The 55 details drawn differently in CAD and Revit

Checked against the new drafters' file, 26 October.

55 of the 190 CAD typical details have a Revit version in your templates that is drawn differently. Each page: your CAD detail on the left, the Revit version on the right, what differs, and one answer: CAD is right, Revit is newer (we update CAD from it), or both wrong.

CAD: KOR-D501-DET 14 - LOAD BEARING STEEL GRATING SECTION

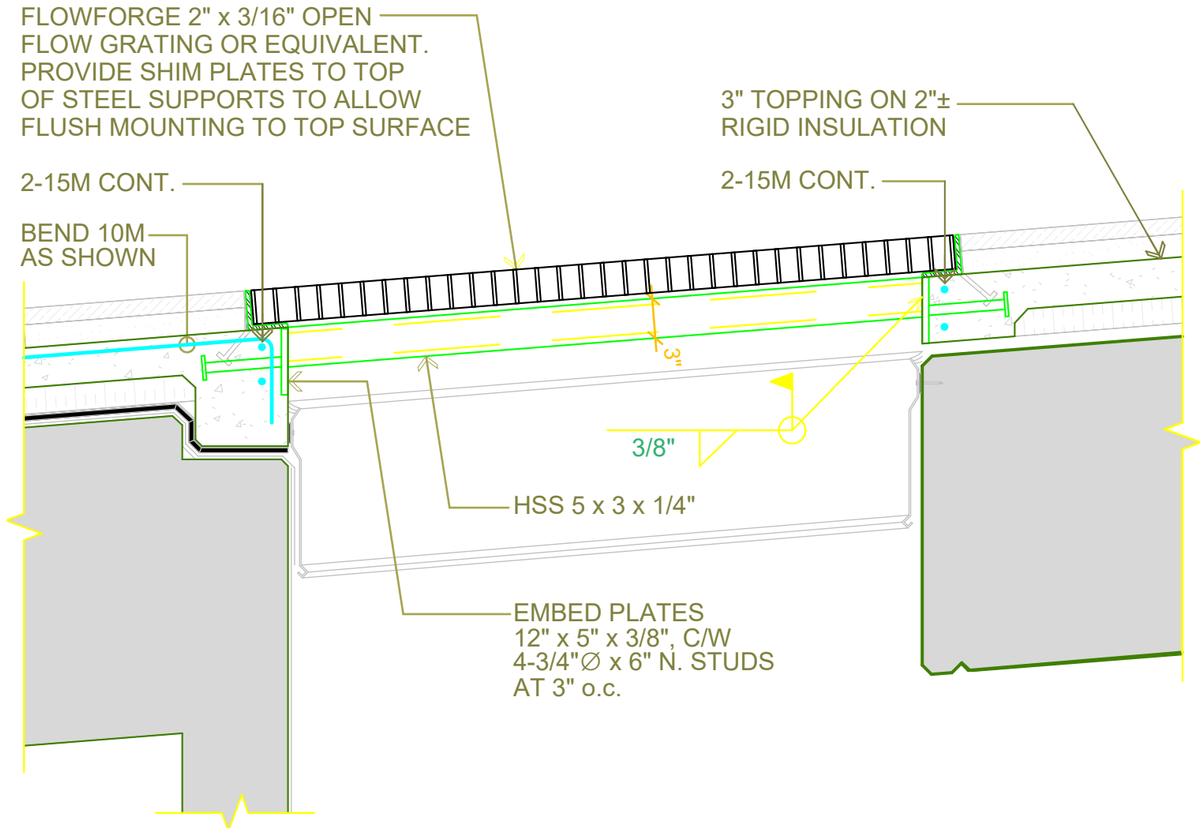
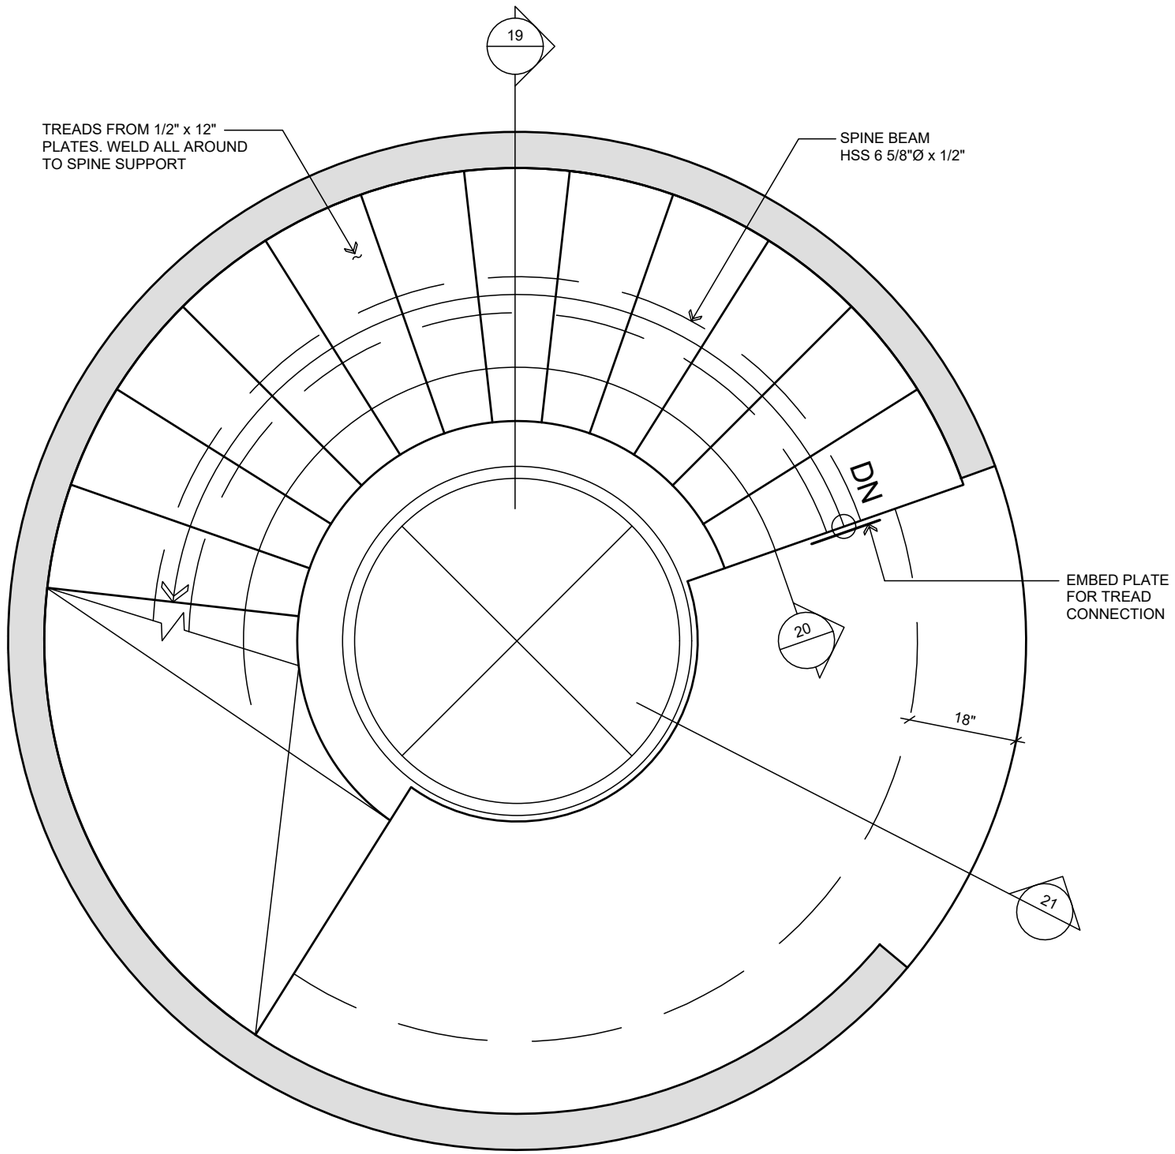
What differs: CAD is the grating support at a wall face with ledger and 10M dowels; 'D5.01_13_LOAD BEARING STEEL GRATING SECTION' is the grating spanning between slab edges.

CAD: KOR-D501-DET 18 - PENTHOUSE SPIRAL STEEL STAIR PLAN

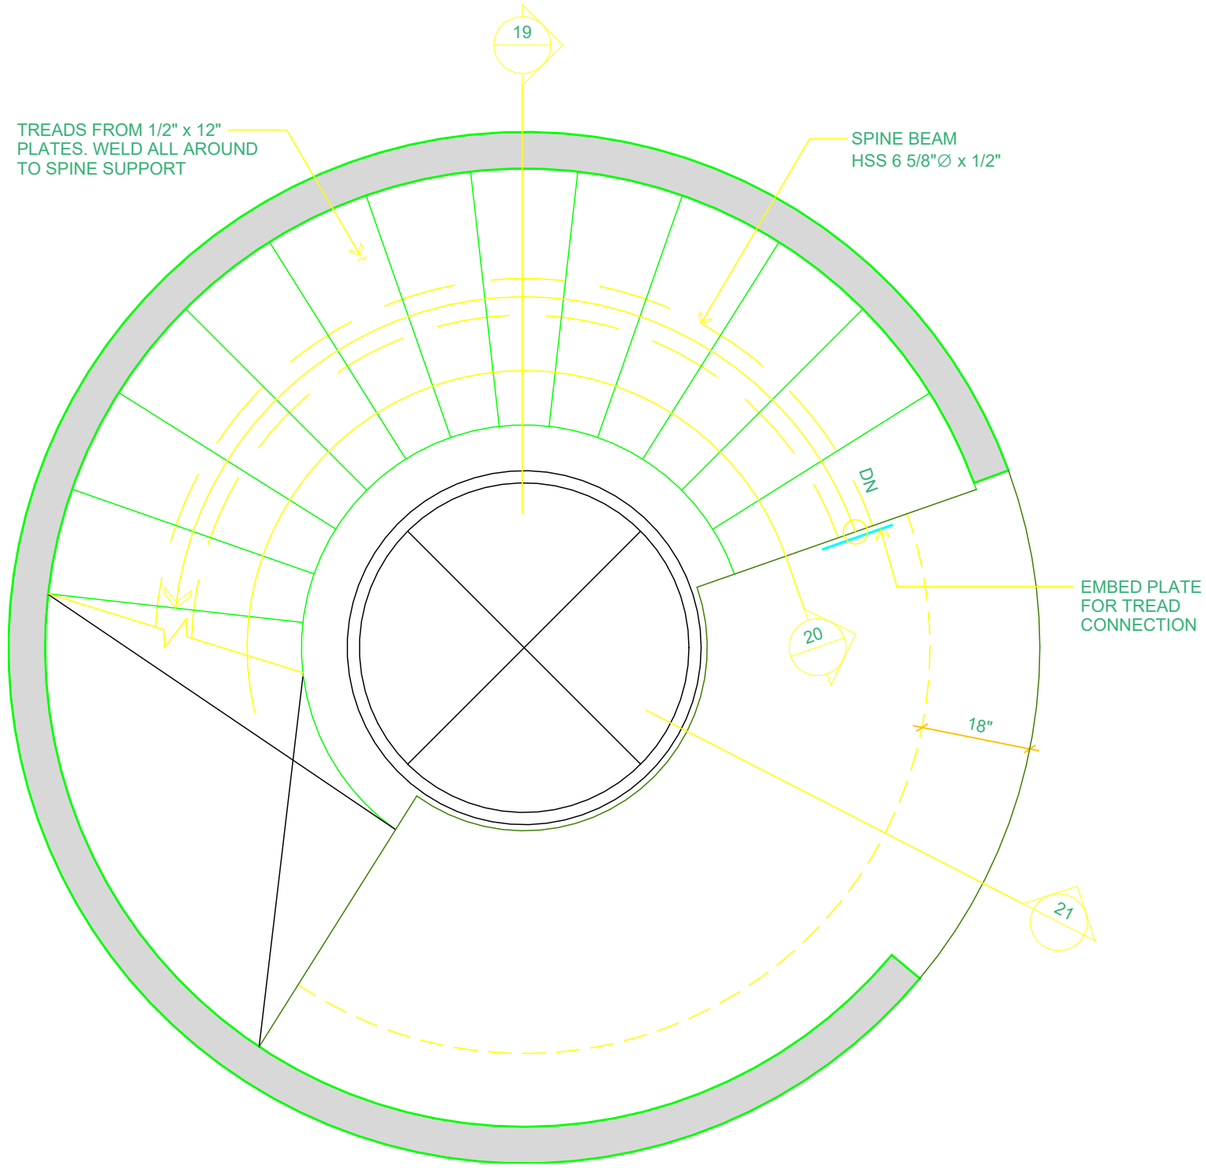
What differs: Same spiral stair plan content (treads, spine beam, embed plates) but CAD plan is drawn elliptical, Revit circular.

Revit: D5.02_10_TYPICAL ON GRADE SLAB THICKENING (Typical Details - Container_R23 (Need_MET & IMP).rvt; on D5.02 Series 5 Miscellan)

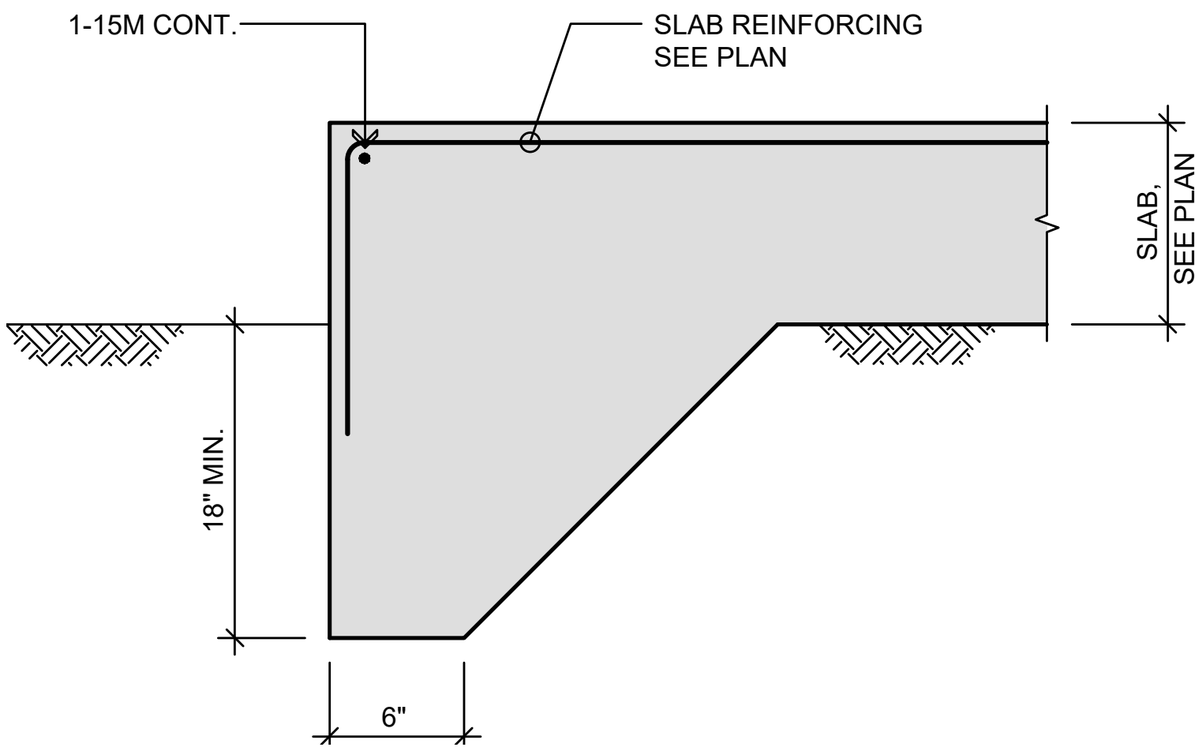
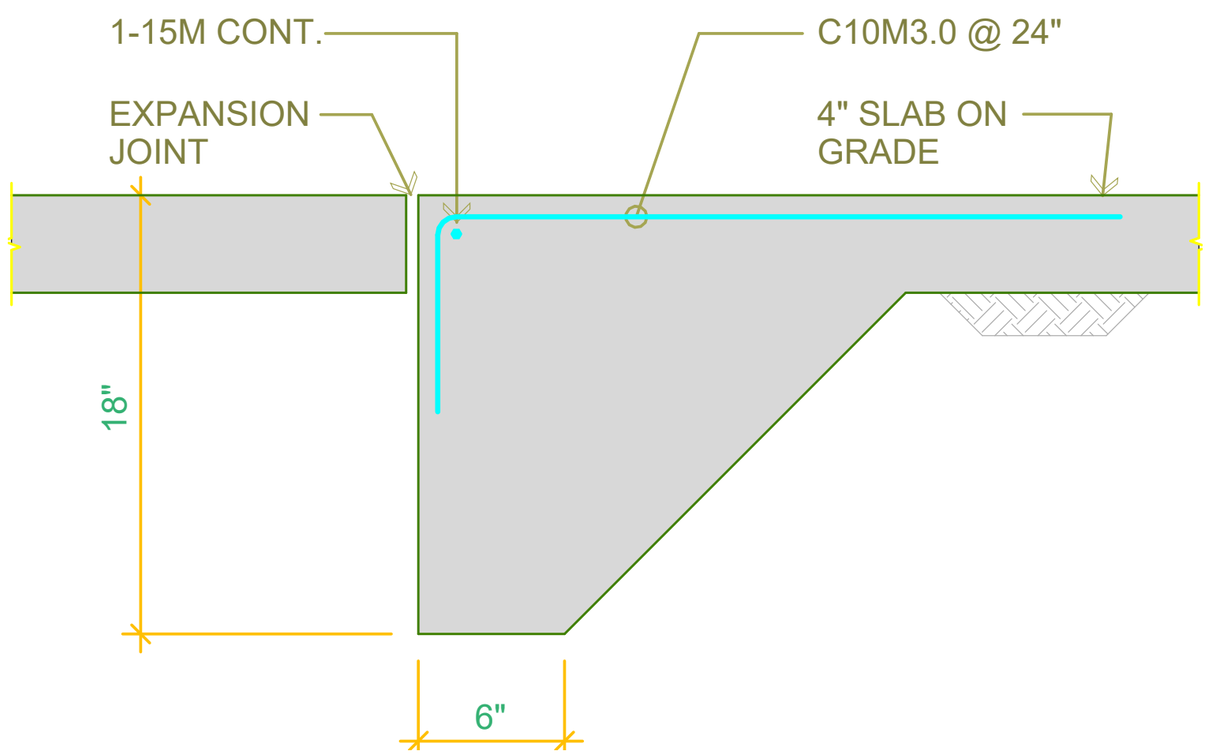
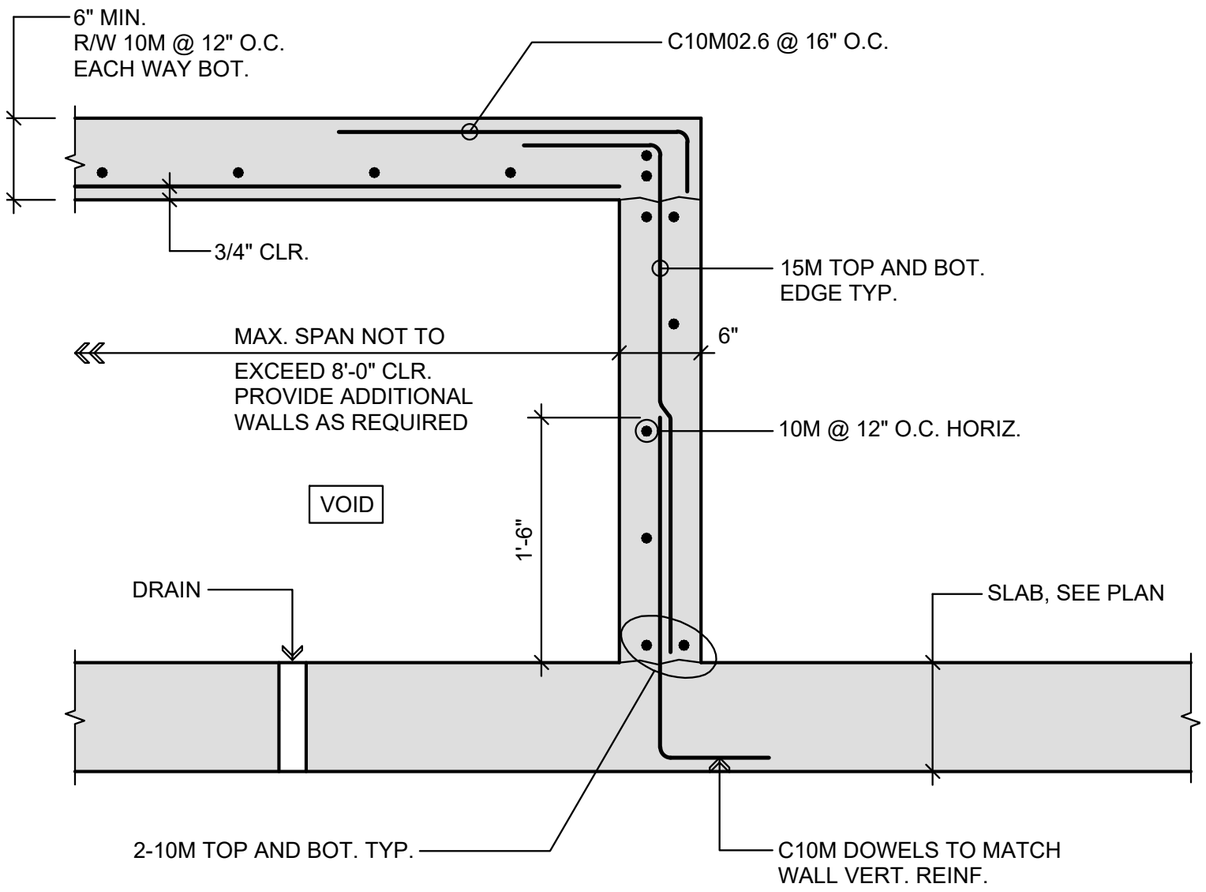
What differs: Thickened slab edge like 'D5.02_10_TYPICAL ON GRADE SLAB THICKENING' but no expansion joint/adjacent slab and different callouts.

CAD: KOR-D502-DET 12 - TYPICAL BUILT-UP SLAB UNO

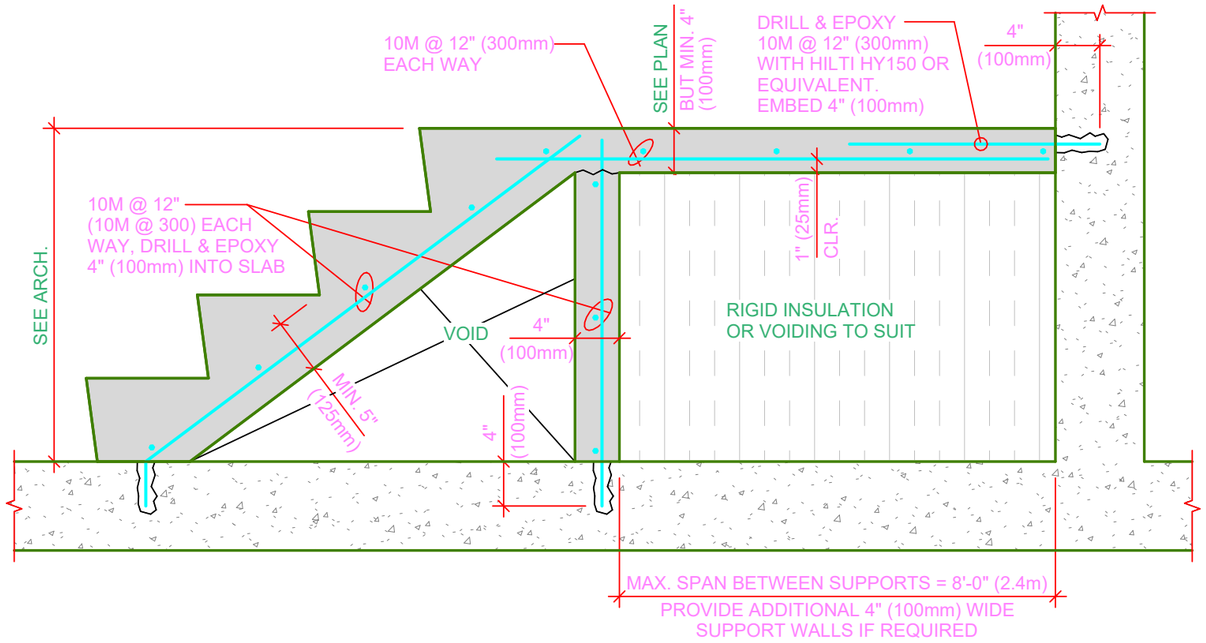
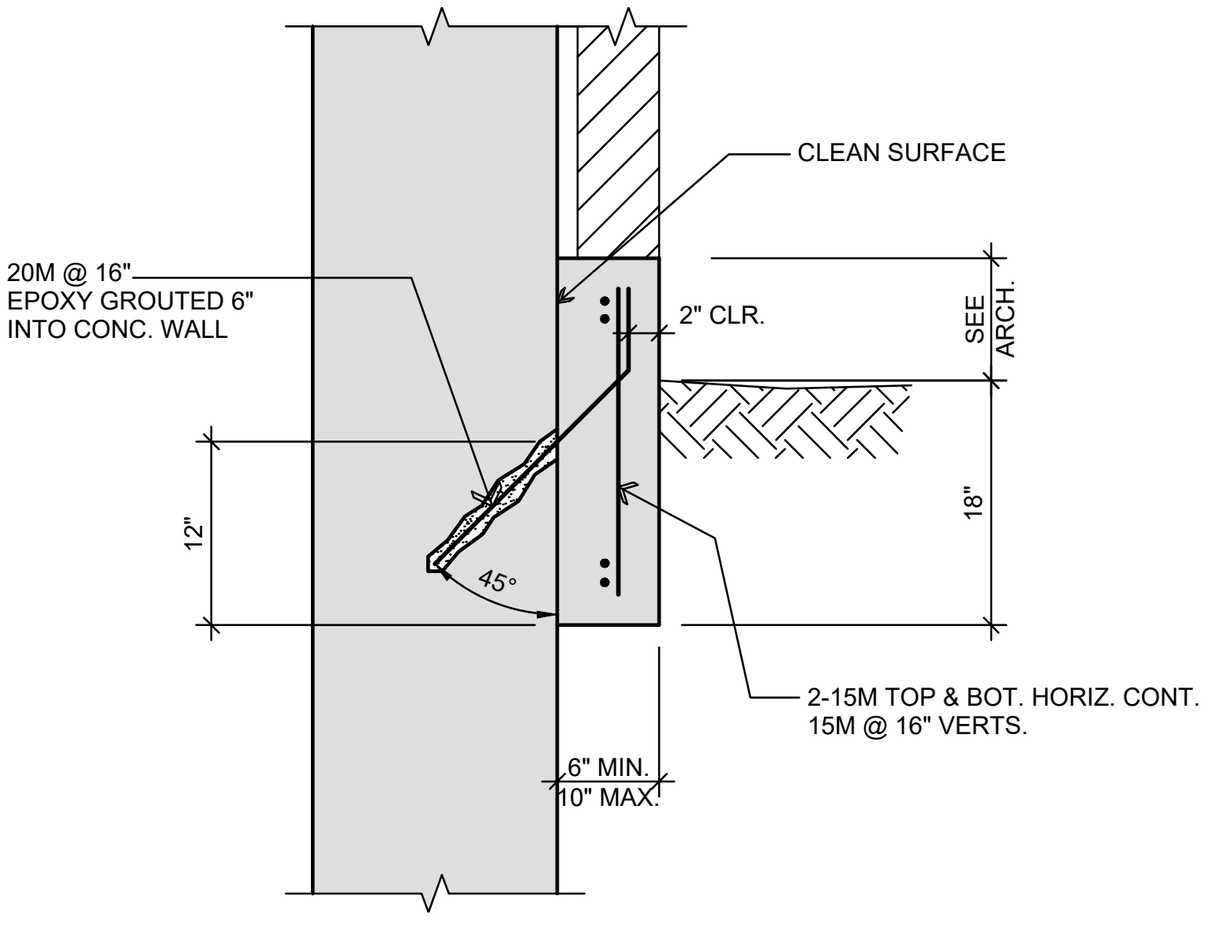
What differs: Both built-up slabs with void and max 8ft span support walls, but CAD is slab on walls with drain, Revit is stepped fill with insulation.

CAD: KOR-D502-DET 18 - POST-CAST CONCRETE BRICK LEDGER

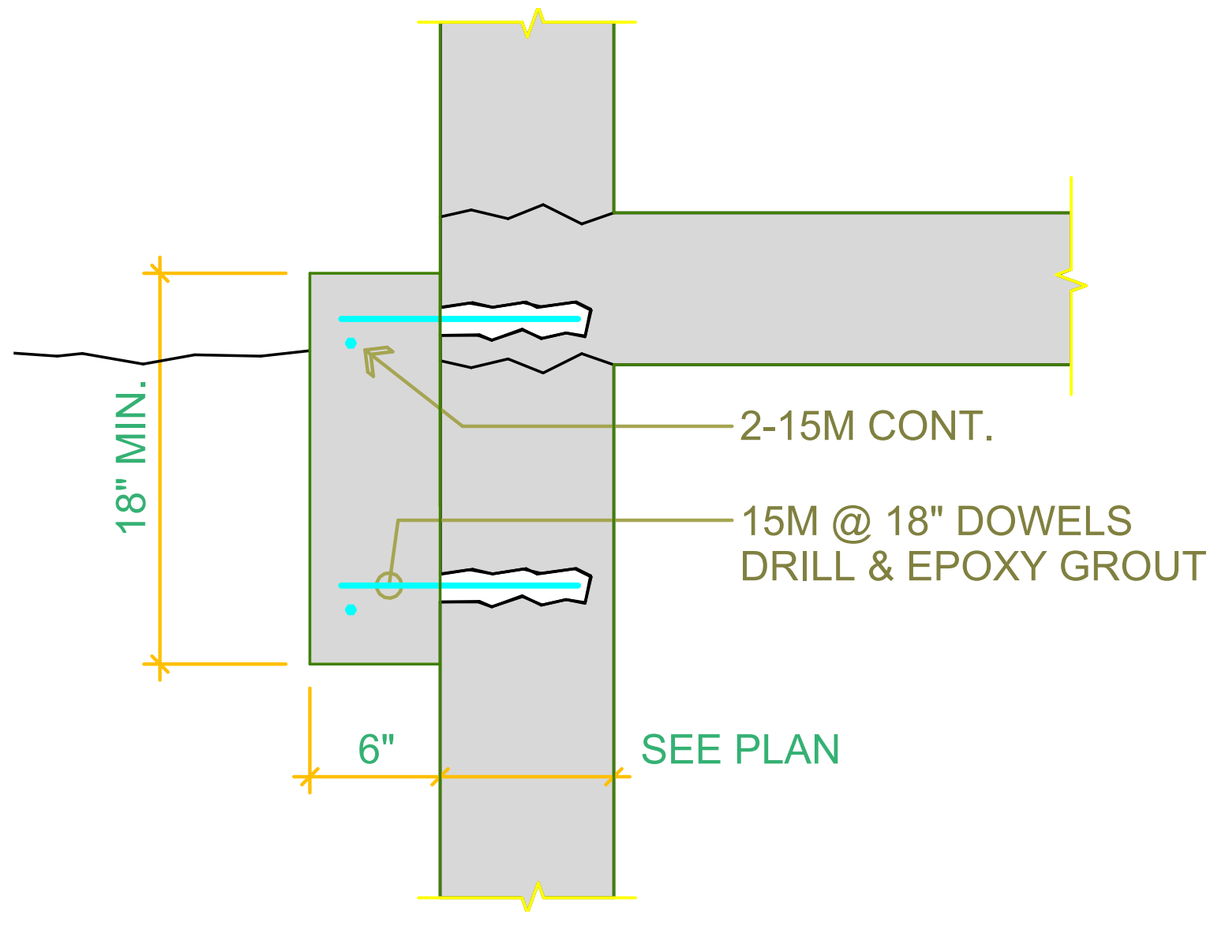
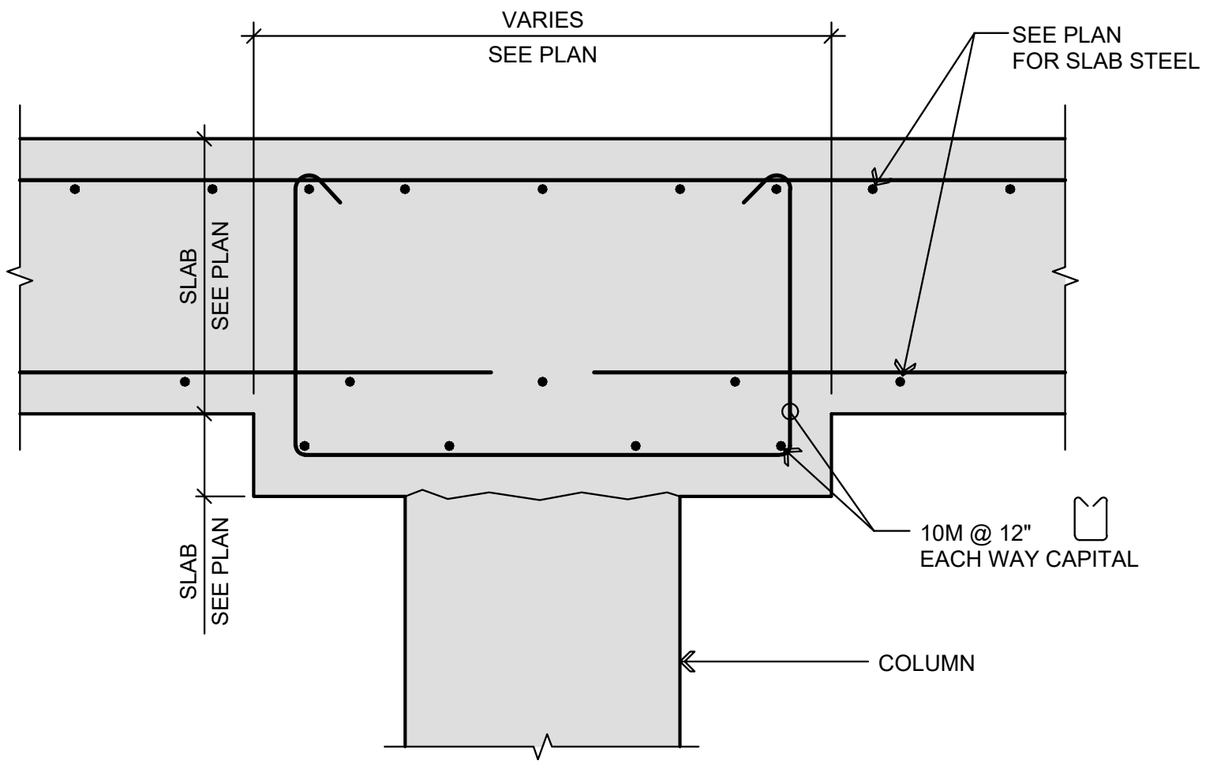
What differs: Both brick ledgers, but CAD is a post-cast ledger with 45 deg epoxied bars, Revit a cast ledger with horizontal dowels.
